STAFF RECOMMENDATION 1623 Sumner Avenue October 17, 2018

Application: New Construction—Infill
District: Eastwood Neighborhood Conservation Zoning Overlay
Council District: 06
Map and Parcel Number: 08306002800
Applicant: Kevin Caine
Project Lead: Melissa Baldock, melissa.baldock@nashville.gov

<p>Description of Project: Application is to construct duplex infill development.</p> <p>Recommendation Summary: Staff recommends approval of the project with the following conditions:</p> <ol style="list-style-type: none">1. The finished floor height be consistent with the finished floor heights of the adjacent historic houses, to be verified by MHZC staff in the field;2. The infill's front setback line up with the front setback of the house at 1621 Sumner Avenue, to be verified by MHZC staff in the field;3. The infill's siding be smooth with a maximum reveal of five inches (5");4. The front doors be at least half glass, and staff approve all windows and doors prior to purchase and installation;5. Staff approve shingle and metal roofing color and textures;6. The HVAC be located behind the house or on either side, beyond the mid-point of the house;7. One or two walkways be added from the str

Site Plan
1623 Sumner Avenue
Nashville, Davidson County, Tennessee

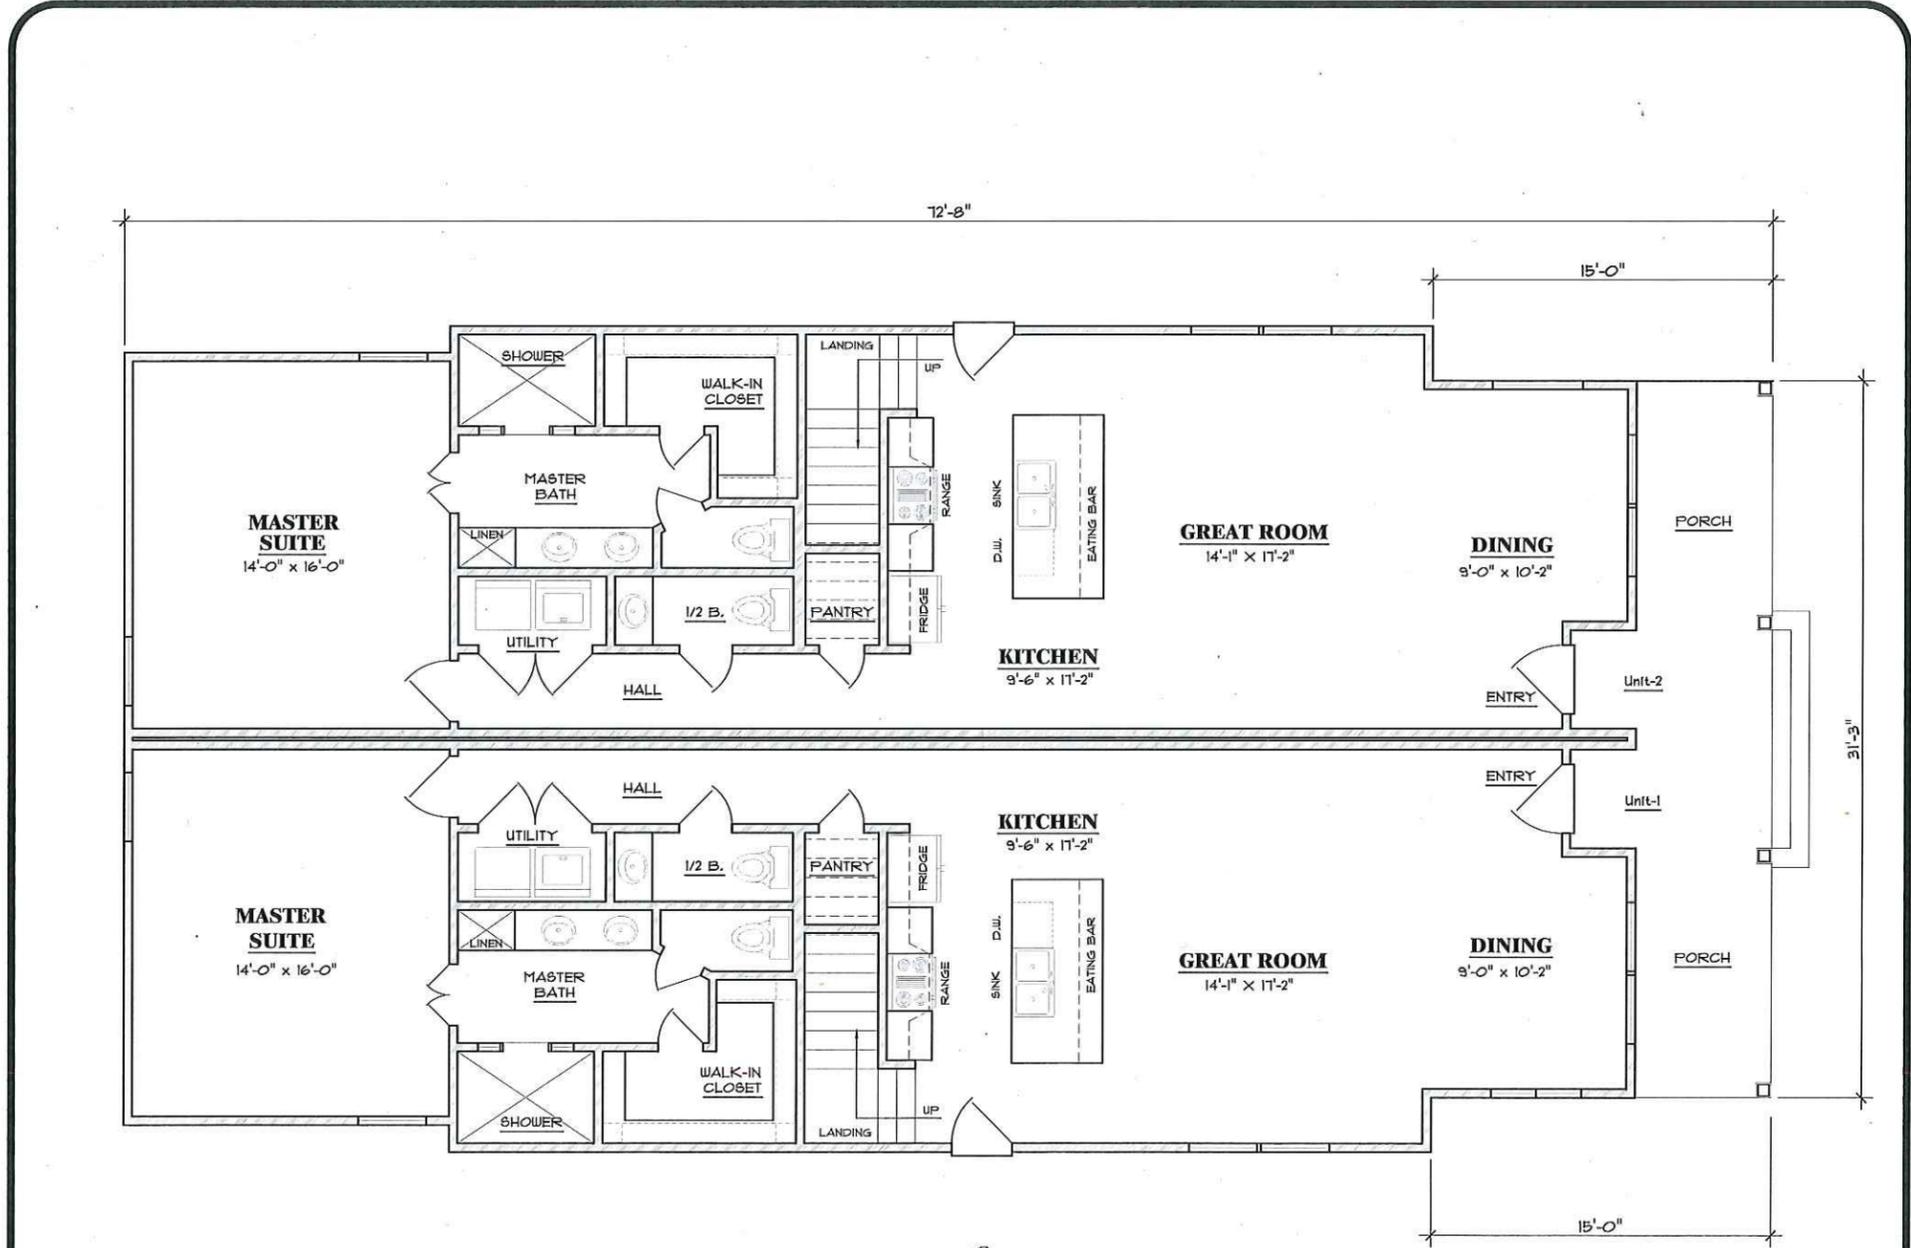
Setback & Rhythm of Spacing: The site plan submitted does not show the front setbacks of the adjacent houses. Because the house to the right, 820 Setliff Avenue, faces Setliff Avenue and not Sumner Avenue, staff recommends that the front setback for 1623 Sumner line up with the front setback of the historic house at 1621 Sumner. The infill will be centered on the lot and will be seven feet (7') from the two side property lines. It will be approximately fifty feet (50') from the rear property line. Staff finds that the infill's setback and rhythm of spacing to meet Section II.B.1.c. of the design guidelines.

1. The finished floor height be consistent with the finished floor heights of the adjacent historic houses, to be verified by MHZC staff in the field;
2. The infill's front setback line up with the front setback of the house at 1621 Sumner Avenue, to be verified by MHZC staff in the field;
